IN THE DRAWINGS

ANNOTATED MARKED-UP DRAWING

Fig. 3

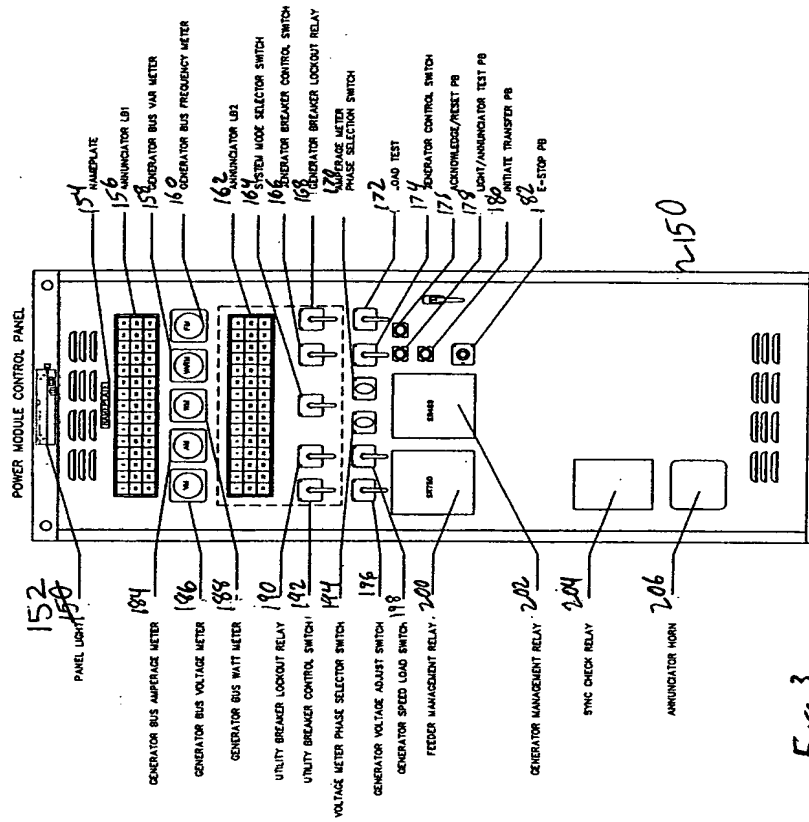
Applicant respectfully requests approval of the following drawing changes. Figure 3 has been amended to change panel light “150” to panel light “152”. Applicant submits, in anticipation of approval of the drawings changes, a replacement sheet for Figure 3. Also submitted herewith is an annotated Figure 3 on which the requested changes are reflected in red ink. No new matter has been added.
